## HISTORIC AND DESIGN REVIEW COMMISSION

**HDRC CASE NO:** 2017-558  
**ADDRESS:** 246 CLUB DR  
**LEGAL DESCRIPTION:** NCB 6702 BLK 12 LOT 17, W 25 FT OF 18  
**ZONING:** R-6, H  
**CITY COUNCIL DIST.:** 7  
**DISTRICT:** Monticello Park Historic District  
**TYPE OF WORK:** Roof replacement (clay tile to shingle)  
**APPLICATION RECEIVED:** October 27, 2017  
**60-DAY REVIEW:** December 26, 2017

### REQUEST:

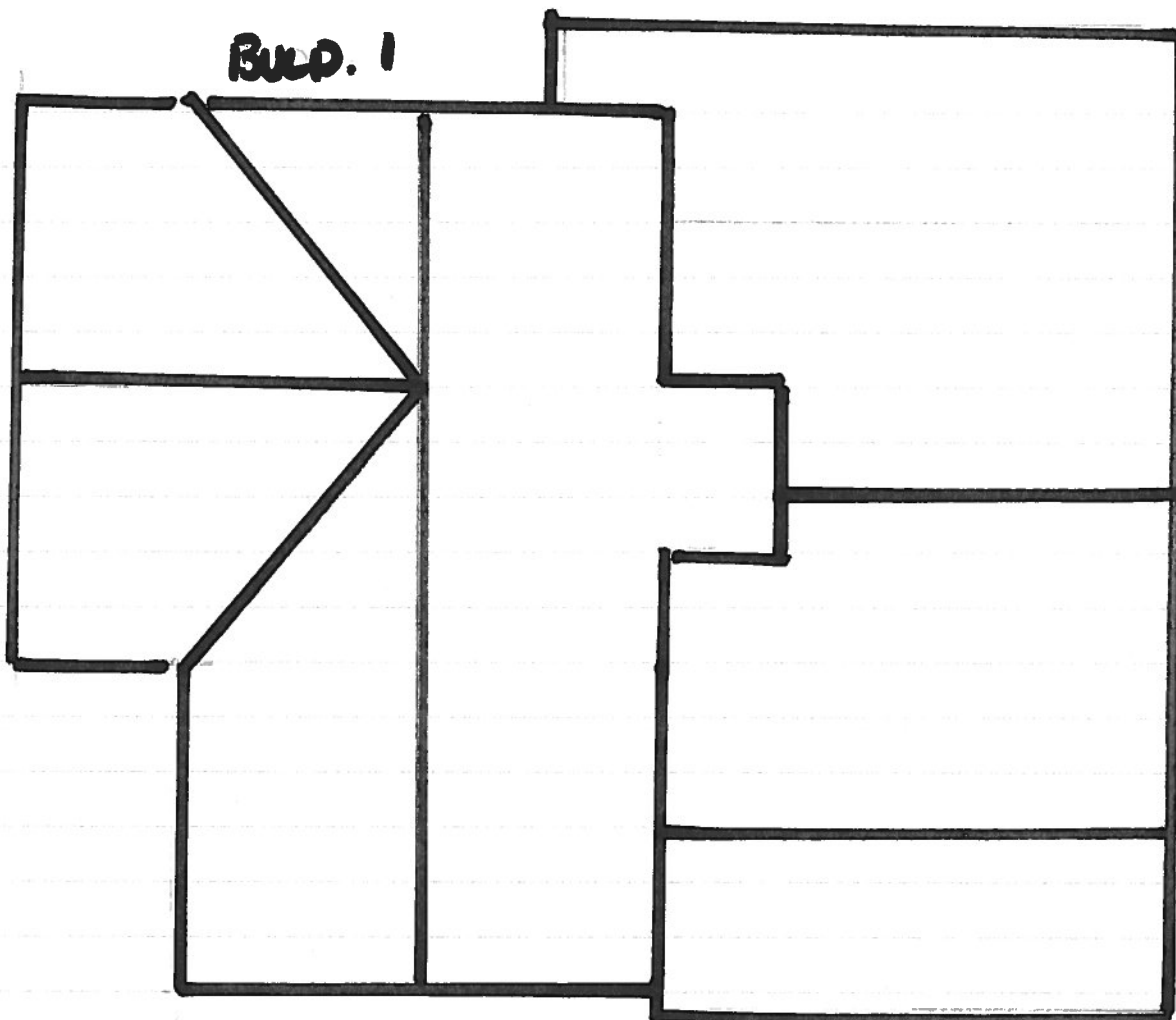
Due to the poor condition of the existing tile roof located at 246 Club Dr. and the sagging existing second story ridge, which is also transferring the weight of the second story tile roof to the framing of the first floor (photos included), it is proposed that the tile roof be removed and replaced with a composition architectural 30 year roof approved by the Historic & Design Review Commission.

Staff does not recommend approval of replacing the primary structure's clay barrel tile roof with composition shingle based on findings b and c. If the applicant cannot repair the existing tile or replace in-kind, a substitute material that is matching in appearance may be proposed.
